UNITED STATES PATENT AND TRADEMARK OFFICE

APPLICATION NO.	FILING DATE	FIRST NAMED INVENTOR	ATTORNEY DOCKET NO.	CONFIRMATION NO.
09/770,296	01/29/2001	Andrew Kevin McParland	50060-042	8376
<div>7590 04/03/2007 McDERMOTT, WILL & EMERY 600 13th Street, N.W. Washington, DC 20005-3096</div>			<div>EXAMINER KNEPPER, DAVID D</div>	
			ART UNIT	PAPER NUMBER
			2626	
SHORTENED STATUTORY PERIOD OF RESPONSE		MAIL DATE	DELIVERY MODE	
3 MONTHS		04/03/2007	PAPER

Office Action Summary

Appln No. 09/770,296
Response filed 11/30/06
Reply to OA dated 5/31/06
REPLACEMENT SHEET

FIG. 1

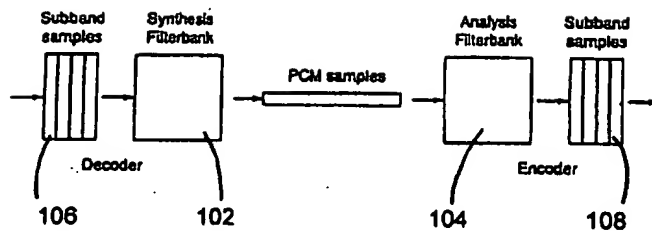
Figure 1 has been labeled as "prior art" indicating that the invention is unlikely to have any non-obvious elements.
